Subject: Duke Energy Carolinas, LLC
Oconee Nuclear Station
Renewed Facility Operating Licenses Numbers DPR-38, DPR-47, and DPR-55;
Docket Numbers 50-269, 50-270, and 50-287
Responses to Request for Additional Information for the License Amendment
Request to Revise Portions of the Updated Final Safety Analysis Report Related to
the Tornado Licensing Basis; License Amendment Request: 2006-009

On July 6, 2009, Duke received a Request for Additional Information (RAI) in regards to the LAR [Ref. 2]. This submittal contains Duke's responses to that RAI. Within this document, the attachment contains Duke's responses to the RAI and supporting documentation is provided in the enclosure.

Duke Responses to RAI

PLAN EL. 783'-9"

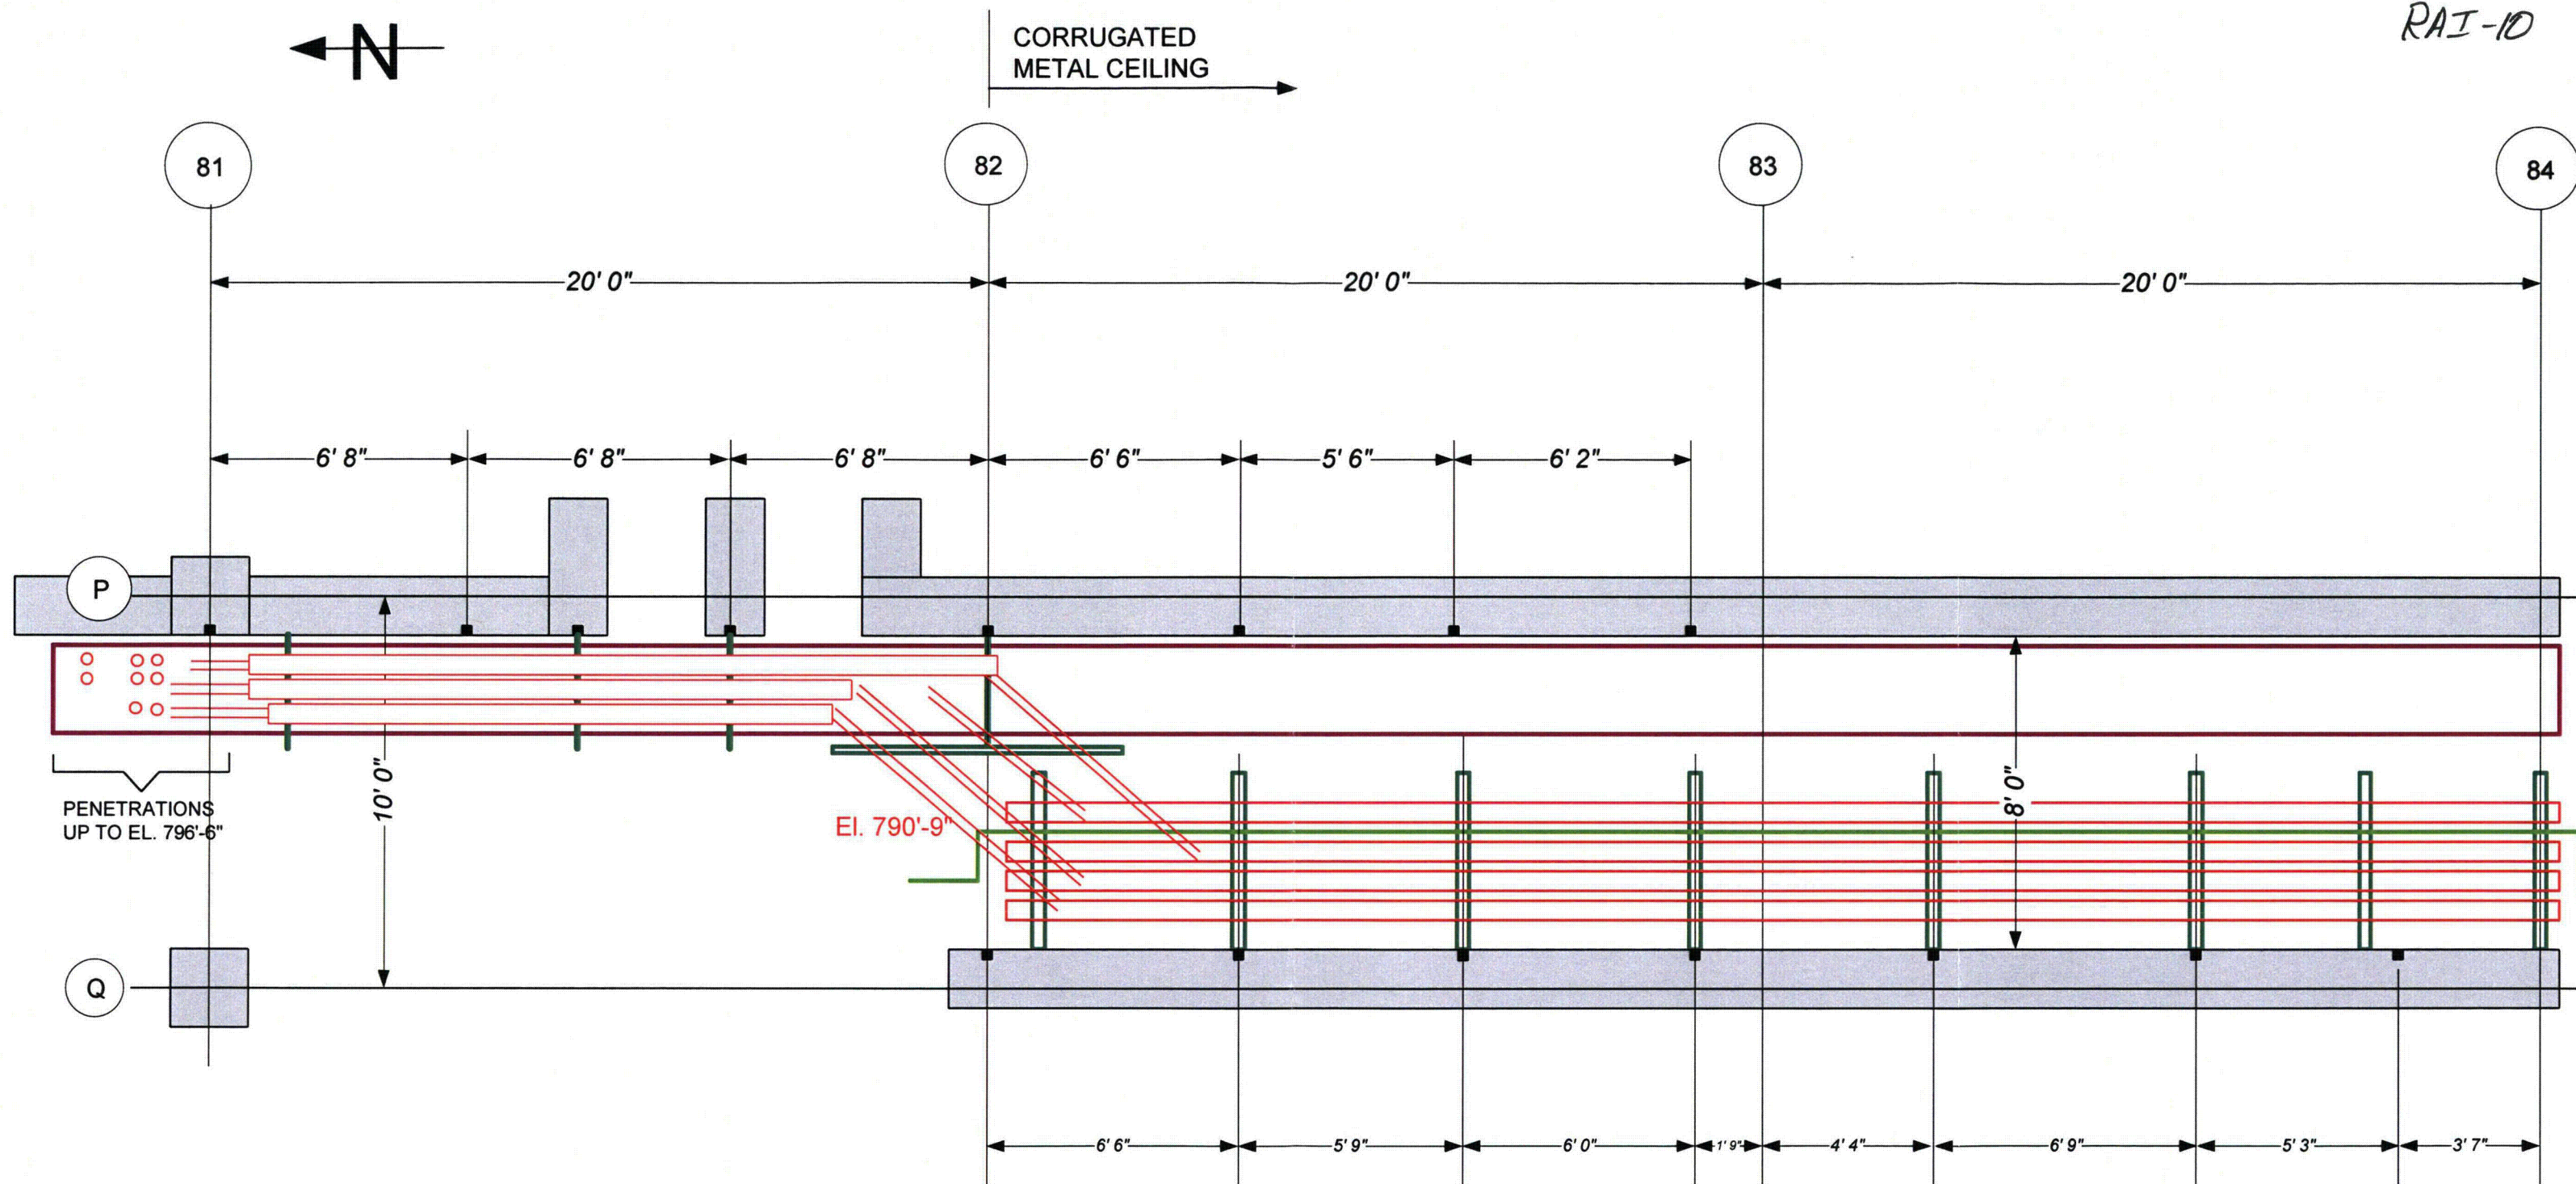
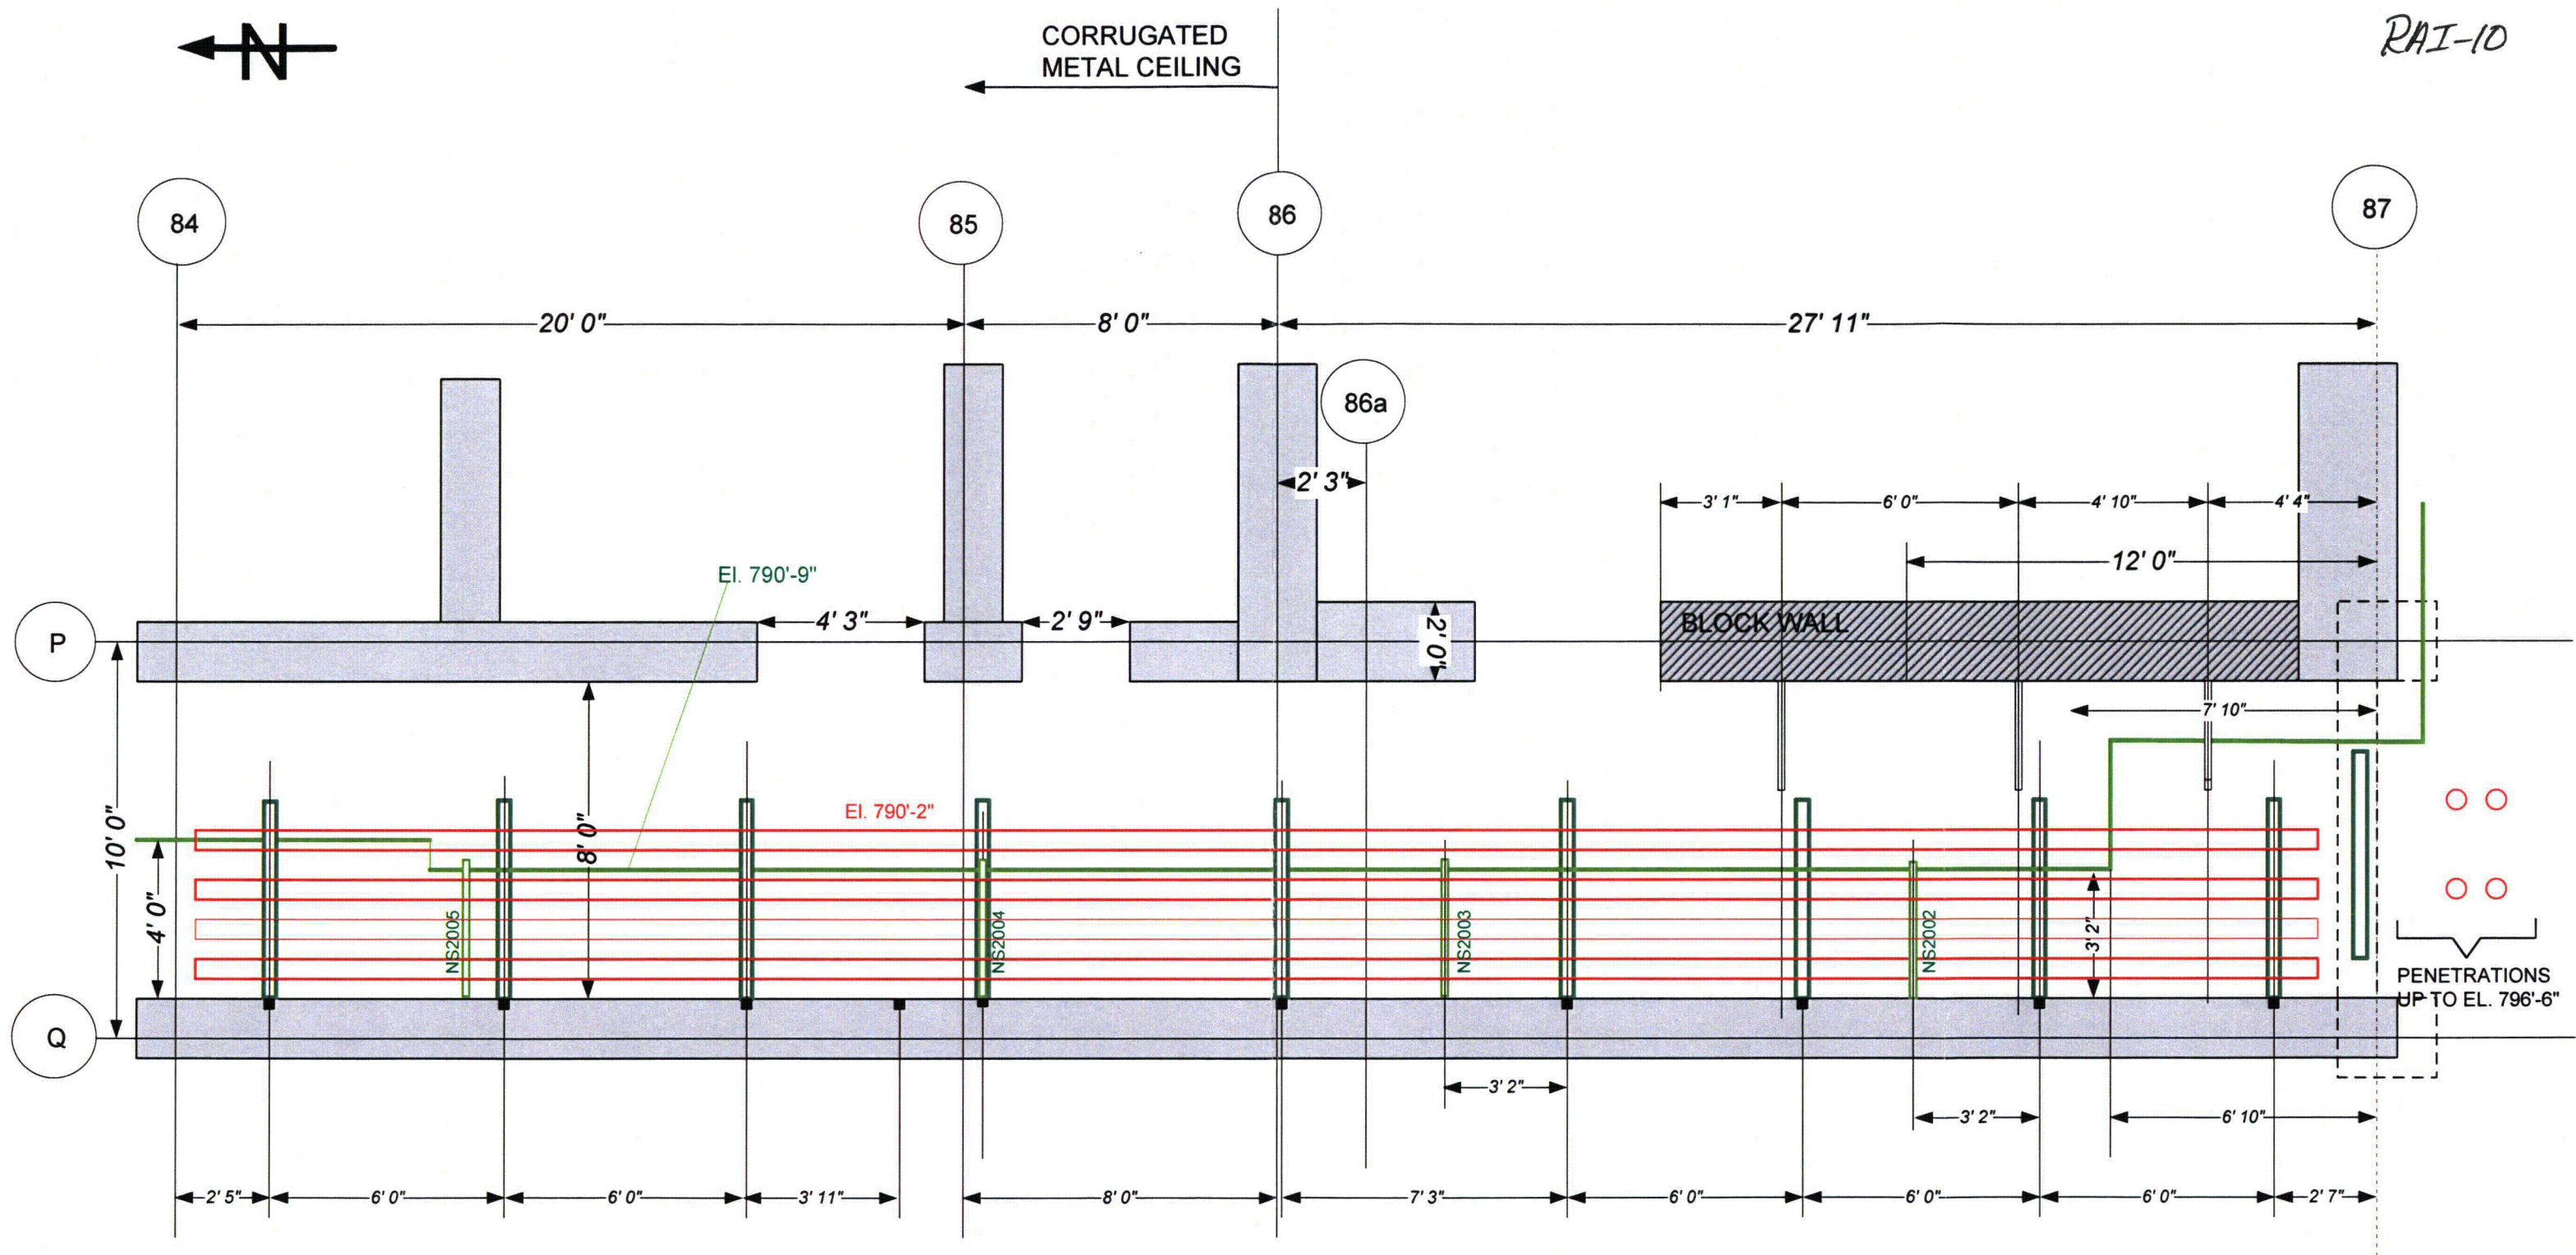
Describe in detail how the 125 VDC vital I&C primary and backup power cables and the KHU emergency start circuitry will be rerouted from the turbine building (TB) to the AB.

This design change provides new routing for the Keowee Hydro Units (KHU) emergency start cables. The existing underground spare cables between KHU and the Oconee Station will be used. For tie-in to control and logic, these underground cables will be extended with new cables between KHU termination cabinets to KHU control panels and Oconee termination cabinets to control panels in the Auxiliary Building. New emergency start cables will be installed from the 230 kV switchyard relay house via a new protected underground duct bank to the PSW switchgear building and, underground via protected duct bank, to the Auxiliary Building control panels.
